Product Change Notice (PCN)

PCN Number: **PCN-0451100R-02**

Product(s) Affected: SJD1-3201-54

<p>Recommended PCB Layout Top View</p>	 <p>Recommended PCB Layout Top View</p>

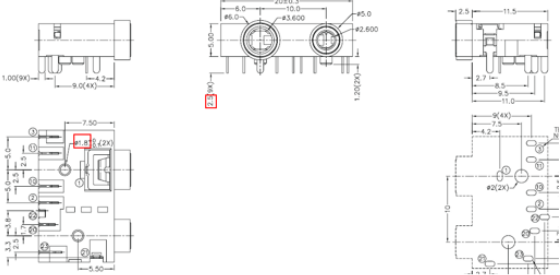
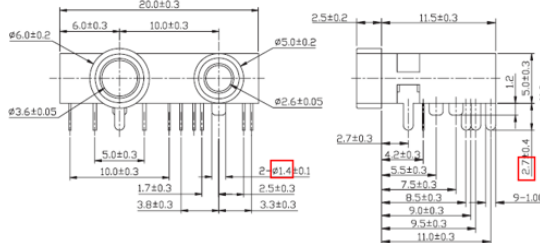
Description of Change: mechanical and material differences as shown below:

MATERIAL	PLATING	DESCRIPTION	MATERIAL	PLATING/COLOR
terminal 1	copper alloy	tin	terminal 1	copper alloy	tin
terminal 2	copper alloy	tin	terminal 2	stainless steel t=0.20	tin
terminal 3	copper alloy	tin	terminal 3	stainless steel t=0.20	tin
terminal 10	brass	tin	terminal 10	brass t=0.40	tin
terminal 11	brass	tin	terminal 11	brass t=0.40	tin
terminal 20	brass	tin	terminal 20	brass t=0.40	tin
terminal 21	copper alloy	tin	terminal 21	phosphor bronze t=0.30	tin
terminal 22	copper alloy	tin	terminal 22	stainless steel t=0.20	tin
terminal 23	copper alloy	tin	terminal 23	phosphor bronze t=0.25	tin
bushing	brass	nickel	bushing	copper alloy	nickel
plastic	PBT		housing	PAB6+GF15% (UL94HB)	black
